**Staff Report**  
**City of Richmond, Virginia**

**Commission of Architectural Review**

5. COA-107856-2022	<b>Final Review</b>	<b>Meeting Date: 3/22/2022</b>
<b>Applicant/Petitioner</b>	Bernard Logan	
<b>Project Description</b>	Rehabilitate a storefront, install a rear landing & stairs, and alter window openings.	
<b>Project Location</b>		
<b>Address:</b> 2430 Venable St.		
<b>Historic District:</b> Union Hill		
<b>High-Level Details:</b> <ul style="list-style-type: none"> <li>The applicant proposes to rehabilitate a storefront, install a rear landing &amp; stairs, and alter existing window openings on a ca. 1909 mixed-use building.</li> <li>The applicant proposes to use TPO to replace existing roofing</li> <li>The rear landing will be wooden with Richmond rail.</li> </ul>		
<b>Staff Recommendation</b>	<b>Approval, with Conditions</b>	
<b>Staff Contact</b>	Emily Routman, <a href="mailto:Emily.routman@rva.gov">Emily.routman@rva.gov</a>	
<b>Previous Reviews</b>	None	
<b>Conditions for Approval</b>	<ul style="list-style-type: none"> <li>Final window and door survey be submitted for staff review and approval.</li> <li>The aluminum of the storefront be painted, and not unfinished; fi

Figure 1. Façade photo

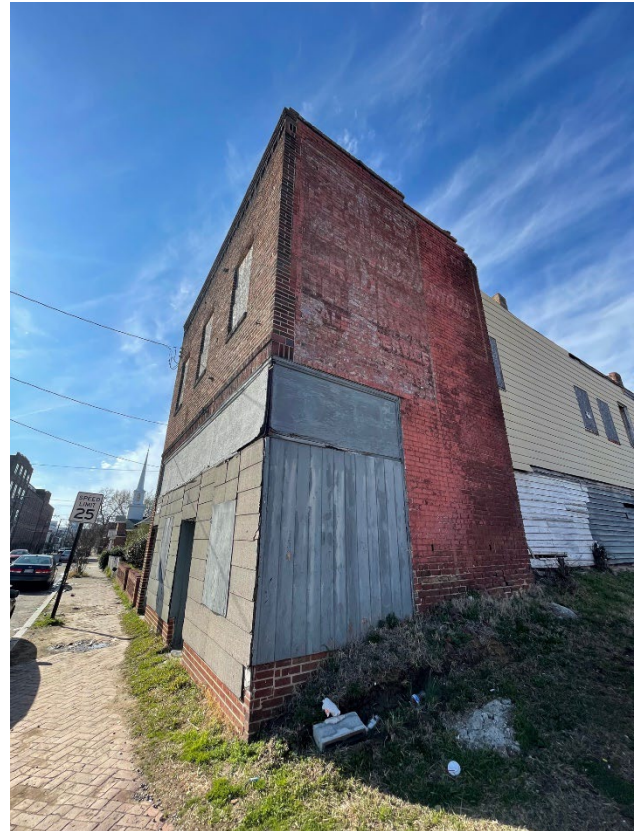
The existing storefront is boarded up. Staff does not know whether or not any original materials associated with the storefront remain. Staff recommends that any salvageable, original storefront elements be maintained and incorporated into the design of the storefront.

Figure 3. West elevation with faux brick siding

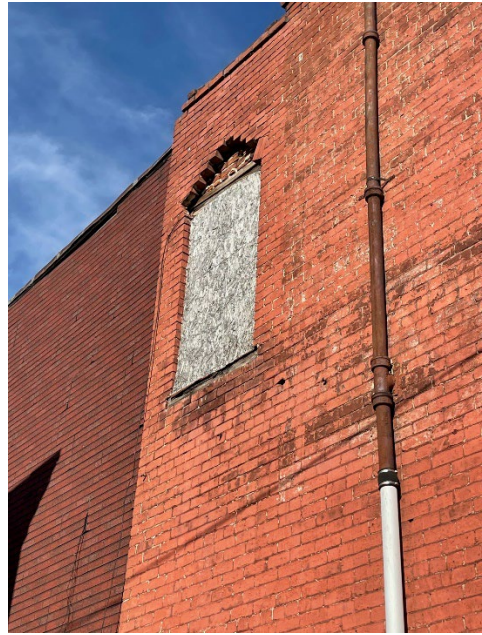
<p>Admin. Approval Guidelines for Fiber Cement Siding</p>	<p>The replacement of wood siding with fiber cement siding may be approved administratively if the following criteria are met:</p> <ul style="list-style-type: none"> <li>• Smooth, unbeaded fiber cement siding is installed on the secondary elevations only. Textured siding should not be used, including faux wood grain finishes.</li> <li>• Secondary elevations have limited visibility from the public right-of-way.</li> <li>• A sufficient amount of existing wood siding is salvaged and installed with the historic reveals on the façade, or wood siding is replaced in-kind on the front façade.</li> <li>• Reveals of the new siding match the historic reveals.</li> <li>• The siding is painted a color or colors found on the Commission’s paint palette.</li> </ul>	<p>The applicant proposes to remove the existing lap siding on the side and rear elevation, replacing with smooth, unbeaded HardiePlank siding. Because the siding is in bad condition, missing, and not located on primary elevations, Staff recommends <u>approval with the condition that any paint colors should be submitted to staff for administrative review and approval.</u></p>
